Your Ref: 130218_EN020002_1658728
Our Ref:
Date: 18th March 2013
Enquiries to: Michael Wilks
Tel: 01473 264064
Email: michael.wilks@suffolk.gov.uk

Infrastructure Planning (Environmental Impact Assessment) Regulations 2009 SI 2263 (as amended) (the EIA Regulations) Proposed Bramford to Twinstead Tee 400kV connection (the project) Proposal by National Grid (the applicant) - Response to Scoping Report of Suffolk County Council

¹⁰ <http://www.iema.net/state-environmental-impact-assessment-eia-practice-uk> Figure 6.3

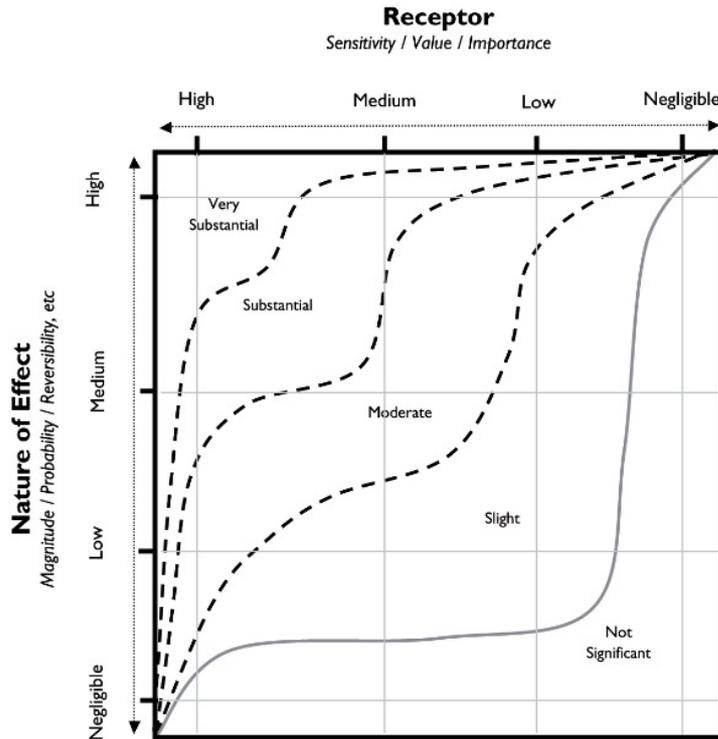
26. The Scoping Report (paragraph 4.1.6) states the assessment of significance of effects will be “broadly based on the...criteria from IEMA’s The State of Environmental Impact Assessments in the UK”. That document includes the following figure¹⁰;

27. It is strongly recommended that National Grid standardises its approach to assessment of effects across the EIA topics as far as is possible so that consistency and comprehensibility is achieved. Any inconsistency will make assessment of in-combination effects particularly difficult.
